Subject: Submittal of Additional Information Concerning Remediation Activities at the
Westinghouse, Waltz Mill Site, Madison, Pennsylvania
License No., SNM-770, Docket No. 07000698

**Response to NRC Letter Dated August 10, 2001
Request for Additional Information
Concerning Remediation Activities**

**Waltz Mill Site
Madison, Pennsylvania**

**Response to NRC Letter Dated August 10, 2001
Westinghouse Electric Company, LLC
Request for Additional Information
Concerning Remediation Activities at the
Westinghouse Waltz Mill Site
Madison, Pennsylvania**

Earth Sciences Consultants, Inc.

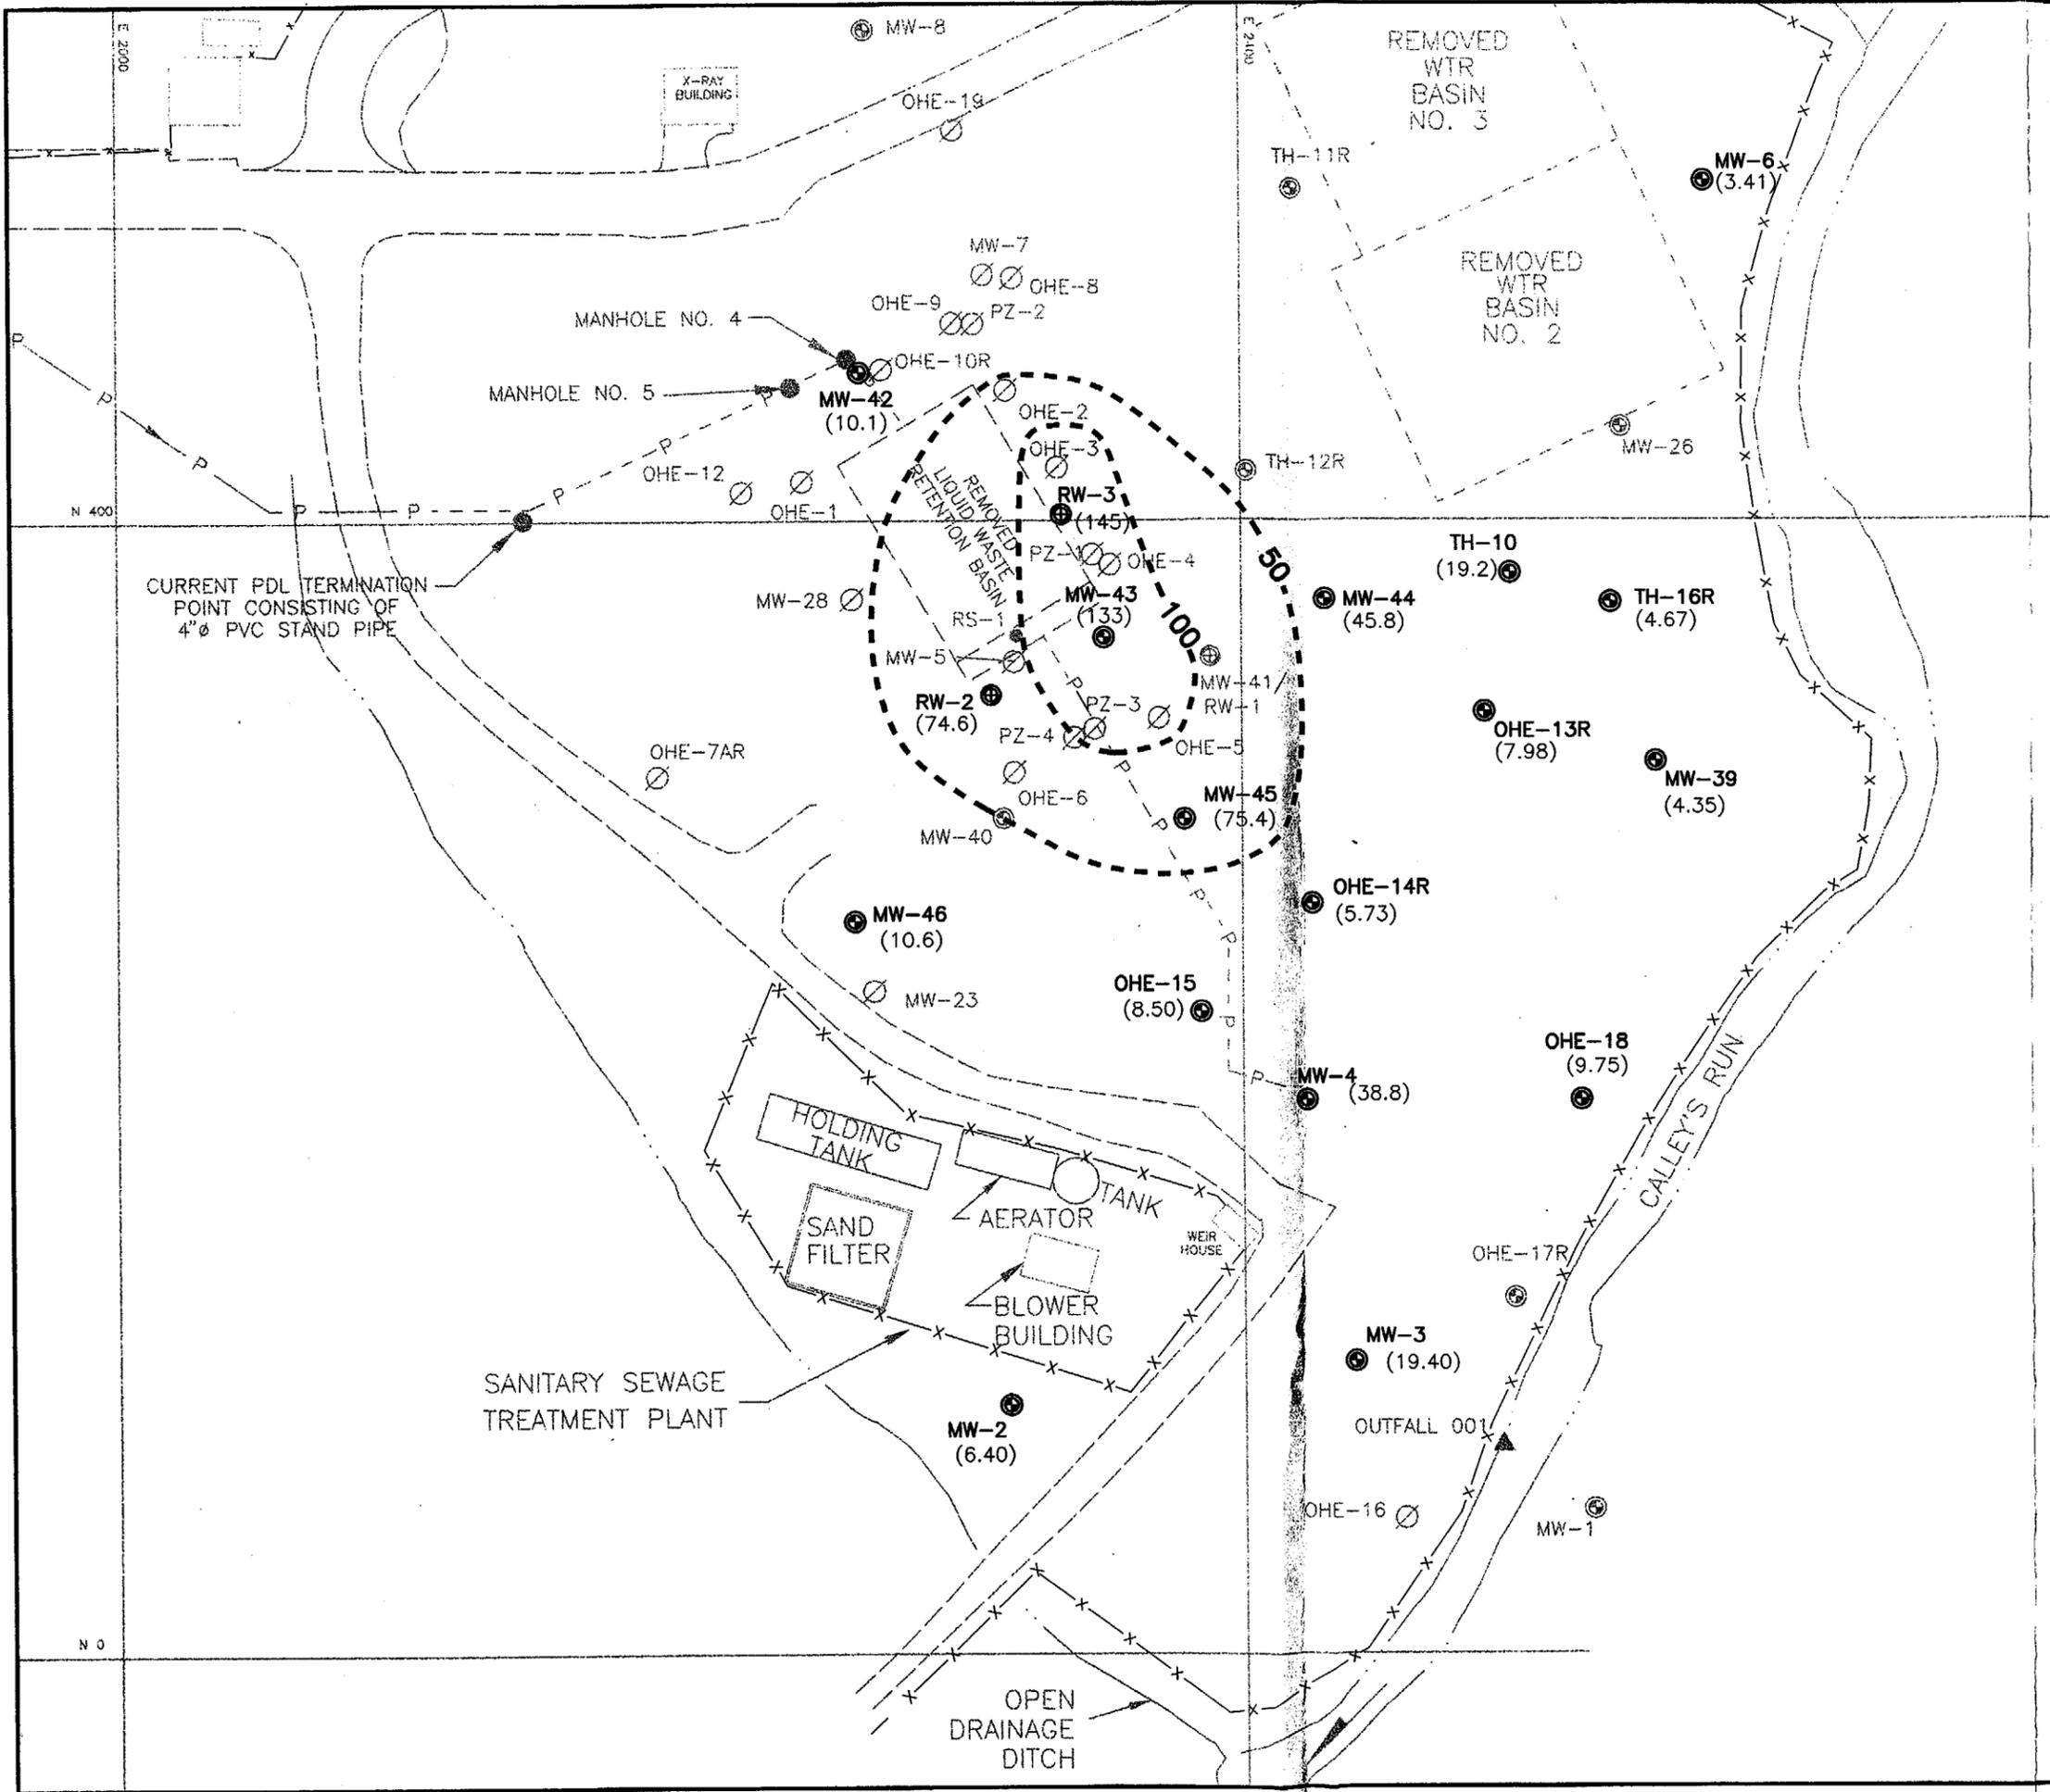
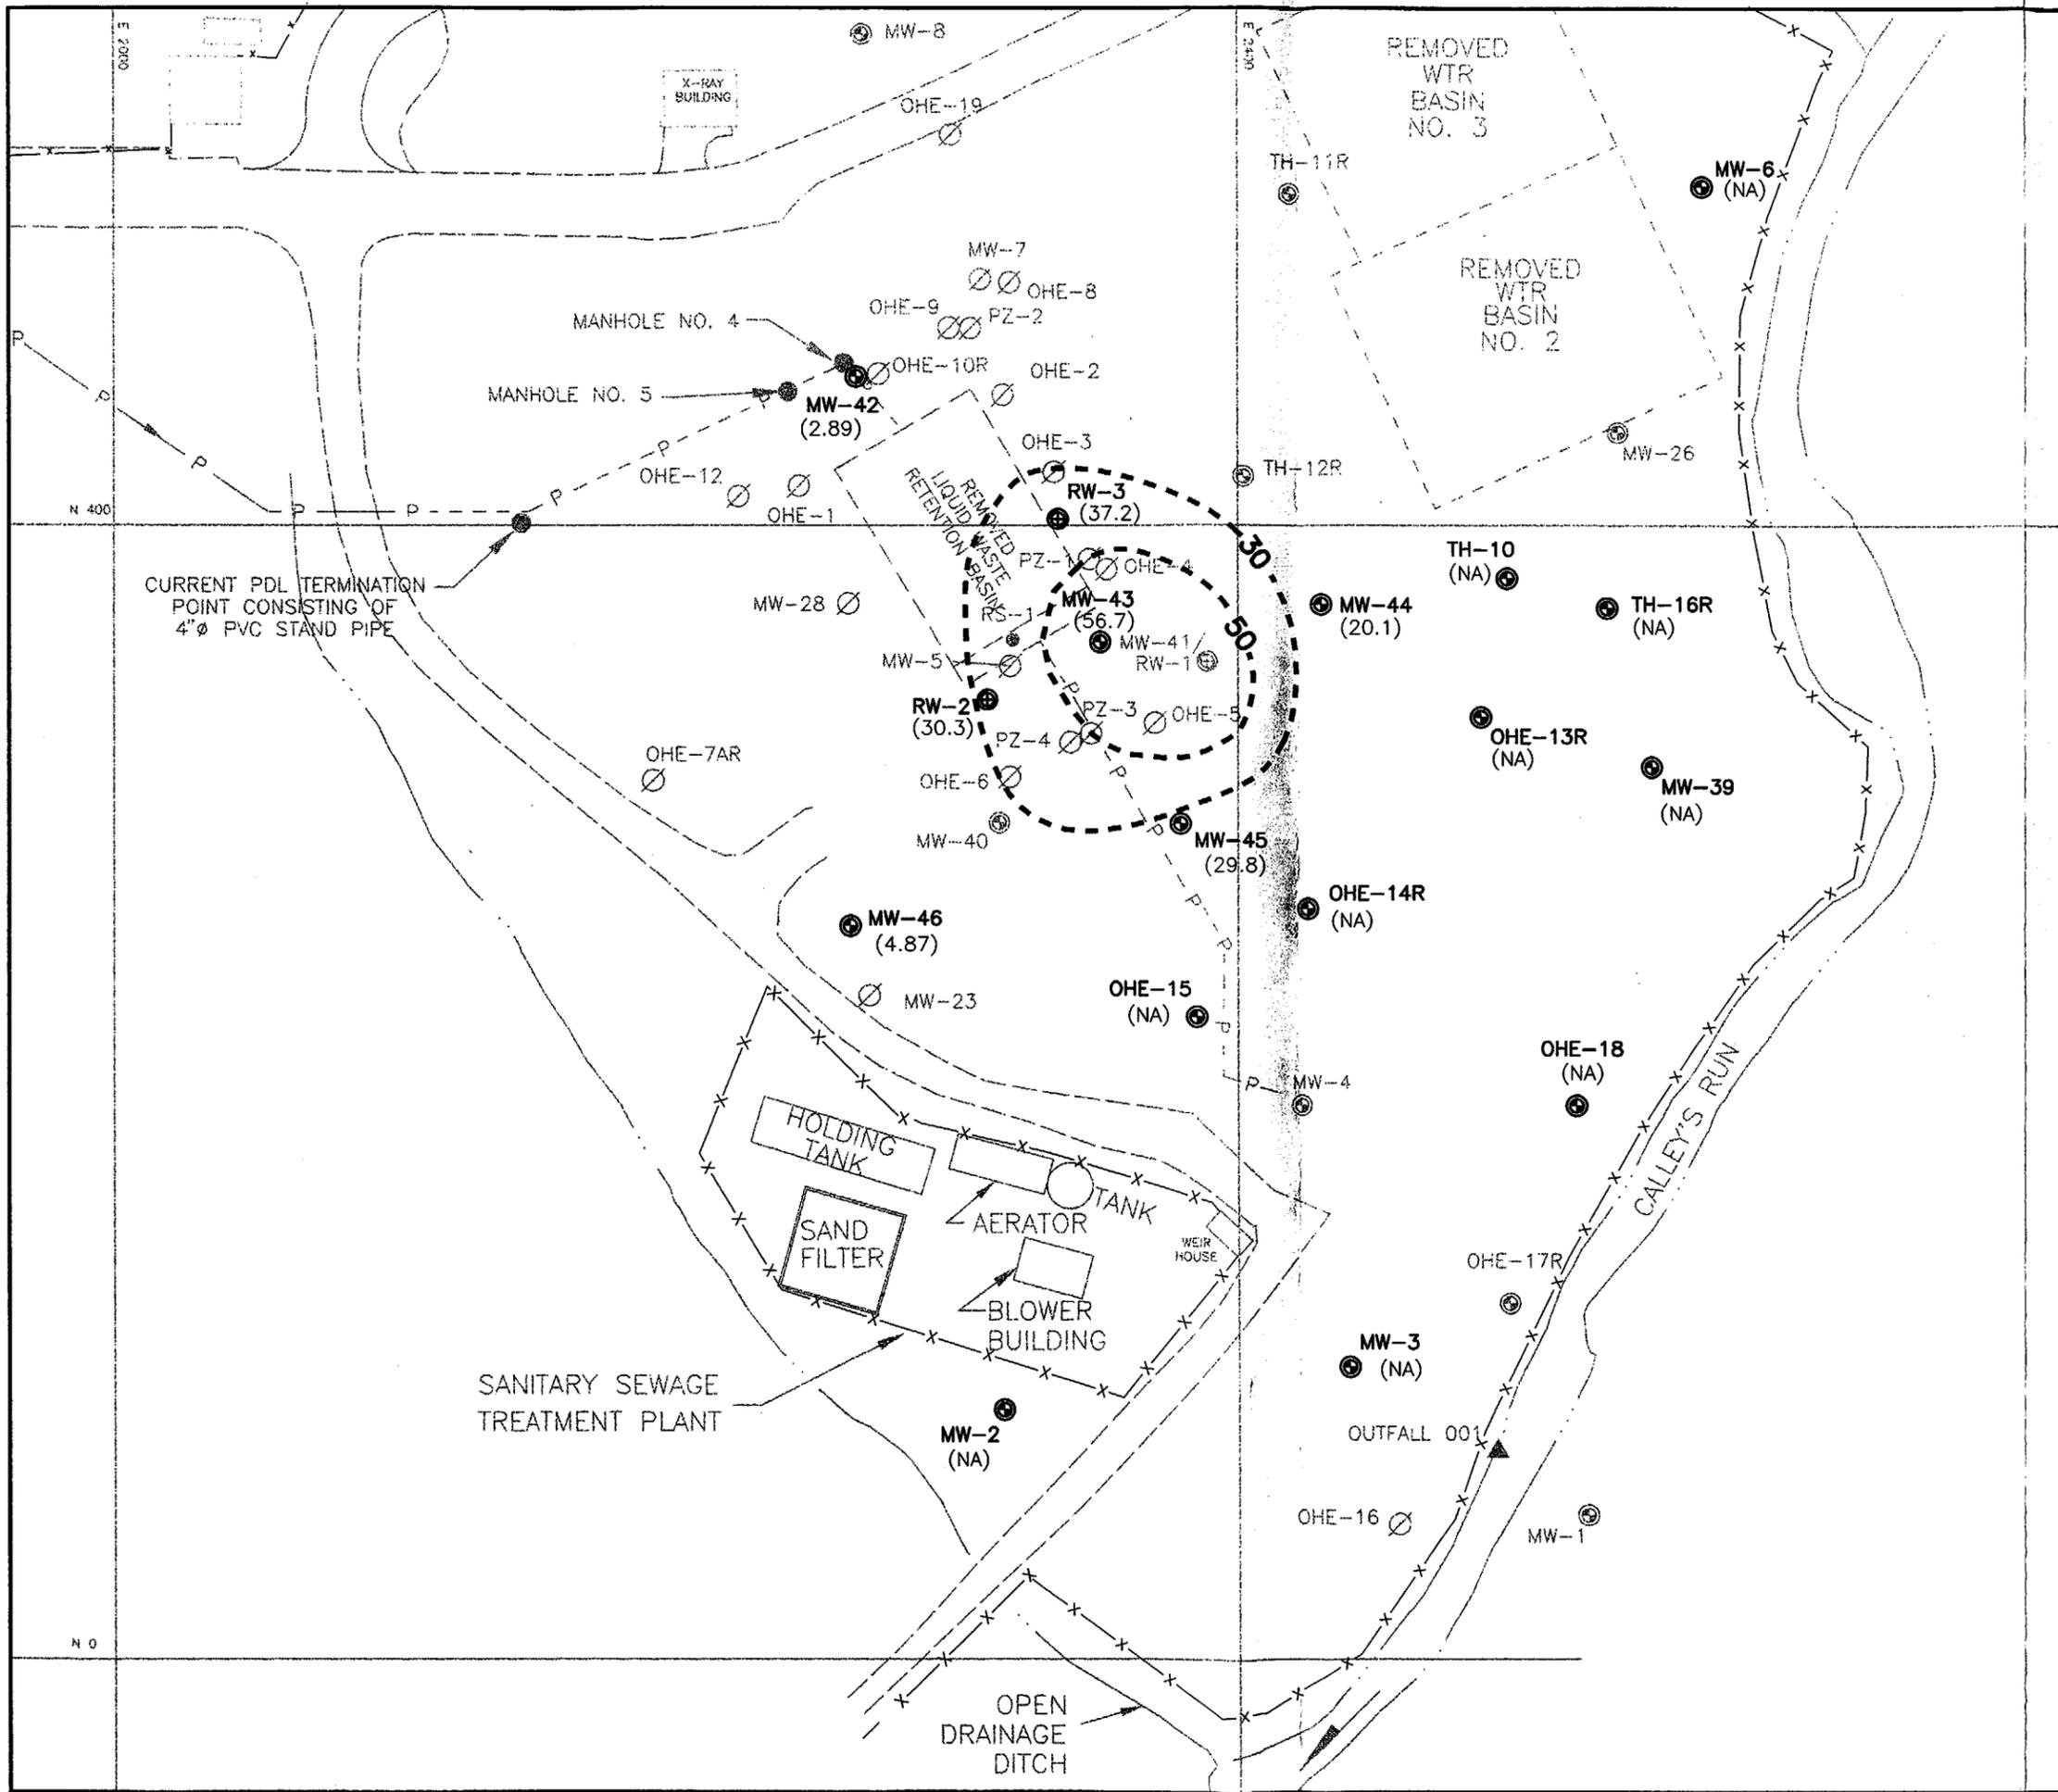
Question No. 4c: In order to evaluate radiochemical data trends for your onsite monitoring wells, please provide radiochemical data obtained since 1999. If possible, please provide the most current map of the groundwater plume configuration, compared to plume configurations measured in the past. Also, please explain the rise in the Sr-90 concentration in Well MW-5 during 1999 from 330 to 575 pCi/liter.

Initial groundwater quality data from the newly installed monitoring and remediation wells have been collected and evaluated. Updated groundwater radiochemistry maps were prepared and are included in Attachment C for comparing preremediation and postremediation groundwater plume conditions. Historical groundwater plume maps were presented in the June 22, 1999 license amendment. Figure C-1 and Figure C-2 illustrate the gross beta/gamma and Sr-90 groundwater plumes before the start of remediation activities (December 1996). Figures C-3 and C-4 illustrate the gross beta/gamma and Sr-90 groundwater plumes based on initial groundwater quality obtained following the completion of soil remediation activities within the liquid waste retention basin area (August 2001).

FIGURE D-2
GEOLOGIC CROSS SECTION C-C'

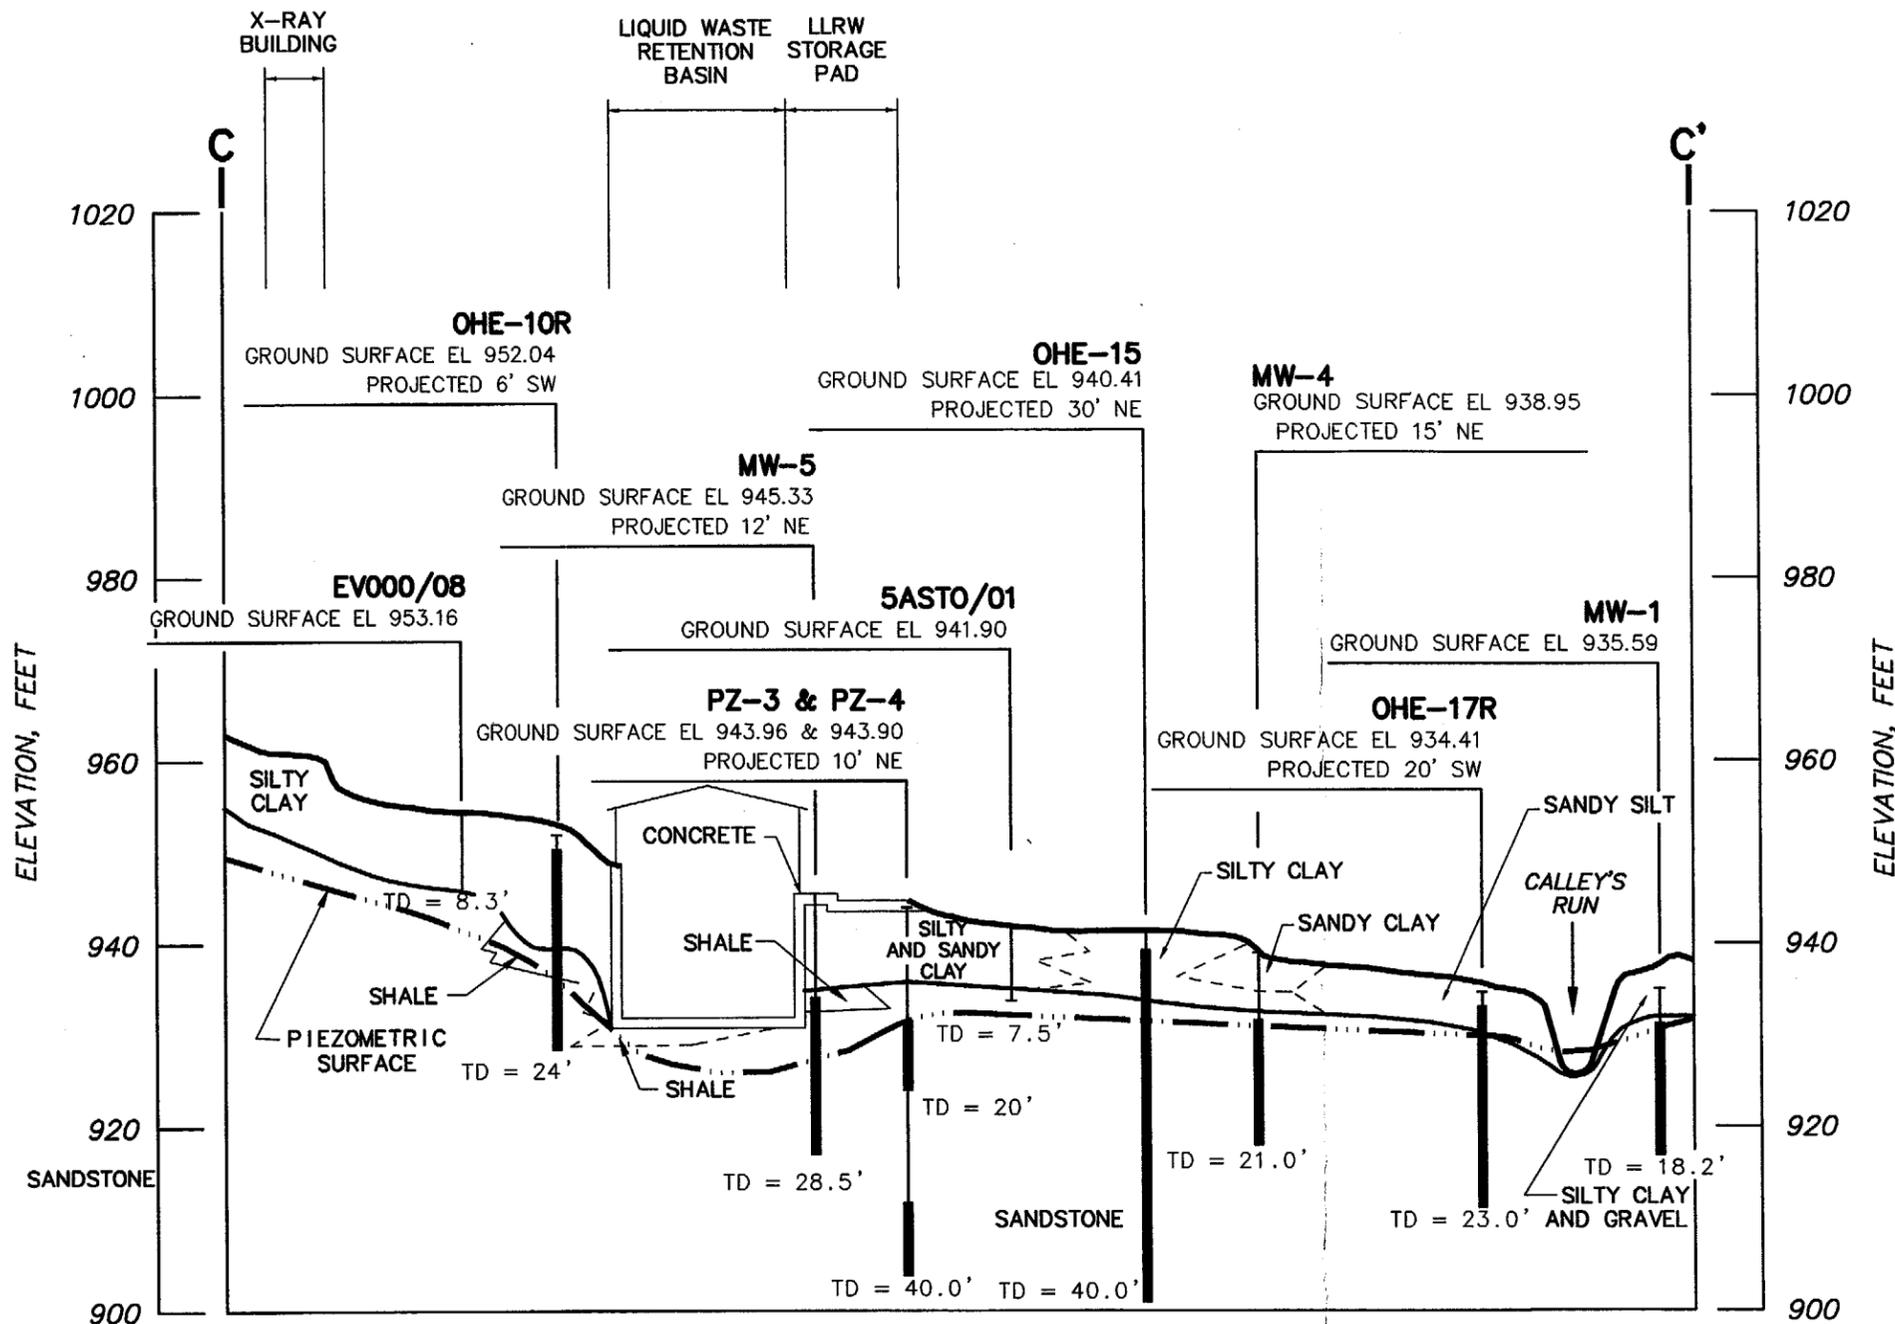
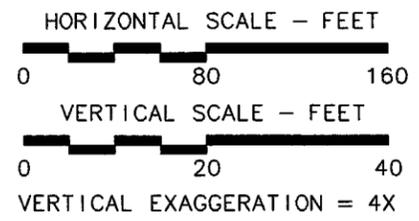
Question No. 7: Does your characterization of groundwater flow confirm that Calley's Run is the local discharge area for onsite groundwater flowing through the contaminated area west of Calley's

Run? What is the impact to offsite dose receptors from the groundwater pathway if contaminated groundwater flows under Calley's Run to an offsite receptor east of Calley's Run.

Response: Geologic Cross Section C-C' (Figure D-2) depicts subsurface conditions beneath and adjacent to Calley's Run. The stream bottom along this section is at an elevation of approximately 928.5 feet above mean sea level. The water depth within the stream can change relatively rapidly following precipitation events. However, based on observations during the soil remediation activities, typical water depth of the stream was observed to be less than 2 feet in wetter times of the year and in drier times of the year the water depth can decrease to several inches.

As a groundwater discharge zone, groundwater to some depth below the stream would discharge into the stream. However, at greater depths, some flow may continue beneath the stream toward the MW-1 area. Well MW-1 was installed historically to evaluate this potential pathway and groundwater results indicate it has not been impacted. Therefore, it can be concluded from this information, in conjunction with the data presented in the response to Question No. 5 (vertical depth of contamination), that Calley's Run does provide a hydraulic barrier to groundwater contaminant migration. Furthermore, groundwater contamination is only minimally reaching monitoring points along the western side of the stream and, therefore, a source of contaminated groundwater does not exist that could move off site east of Calley's Run.
